**UPPER UWCHLAN TOWNSHIP
PLANNING COMMISSION
AGENDA**

Reference: Windsor Baptist Church – Proposed School Building
Preliminary Land Development / Conditional Use Review
Upper Uwchlan Township, Chester County, PA

G&A has completed our second review of the above referenced Preliminary Land Development for compliance with the applicable sections of the Township's Zoning Ordinance, Subdivision and Land Development Ordinance, and Stormwater Management Ordinance, and wish to submit the following comments for your consideration.

Detail of Eagleview Lot 4
Preliminary/Final Land Development Plan

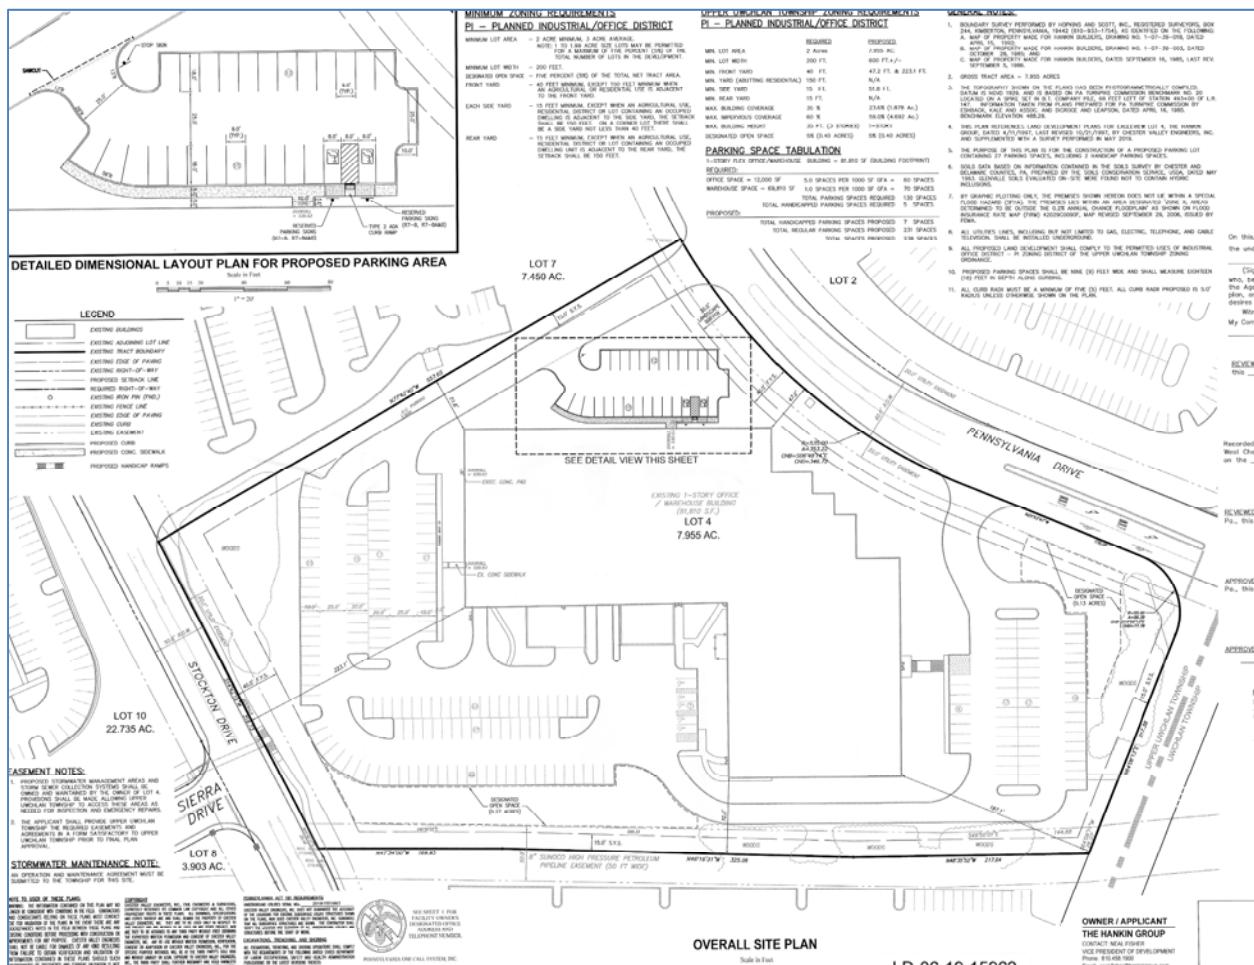
2. **Watersheds**, the water resources component of *Landscapes3*, indicates the proposed development is located within the Shamona Creek subbasin of the Brandywine Creek watershed. **Watersheds'** highest priority land use objectives within this watershed are:

Detail of Handicap Parking Space Locations

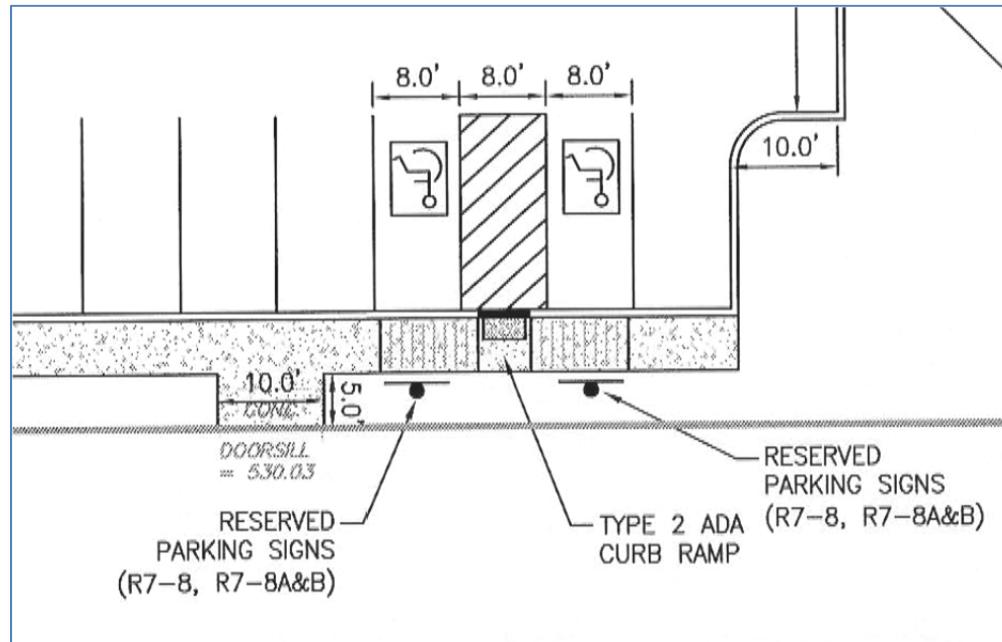
3. We suggest that the two handicap parking spaces would be more convenient to use if they were relocated directly opposite the entry door, instead of being offset to the east (refer to the detail below).
